NEMA Comments on Draft ENERGY STAR® Program Lamp Specification

**National Electrical
Manufacturers Association**

**NEMA Comments on ENERGY STAR® Program Requirements
Product Specification for Lamps (Light Bulbs)
Eligibility Criteria Version 1.0, DRAFT 1**

NEMA Comments Figure 1

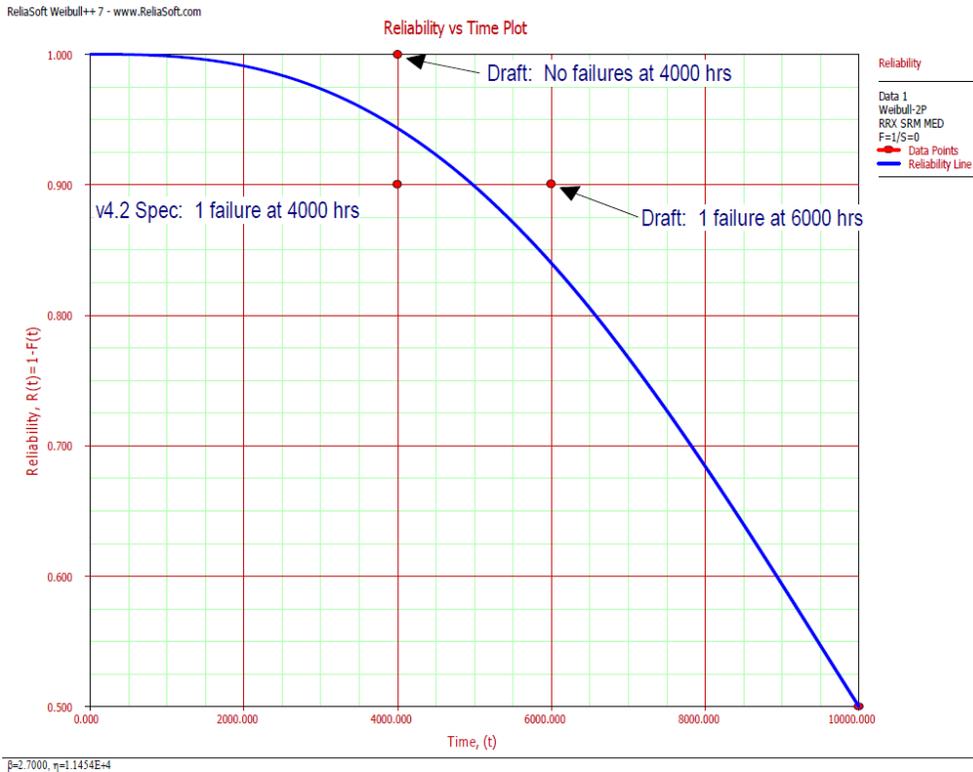
- In the draft, Energy Star attempts to define a reliability curve for CFLs with specific reliability targets at 40% of life and 6000 hours. Such a curve is shown in Figure 1 for CFLs tested under nominal conditions, i.e. 25C with a B50 life of 10,000 hours. Using this as an example, the figure shows that 6% failures could be expected at 4000 hours. Thus, it is not realistic to expect zero failures, i.e., 100% reliability, at 4000 hrs. The existing specification acknowledges this by allowing at least 1 failure at 4000 hrs for a 10,000 hr lamp. NEMA recommends the CFL reliability requirement be maintained from the Energy Star CFL 4.2 specification. Please see the chart below.
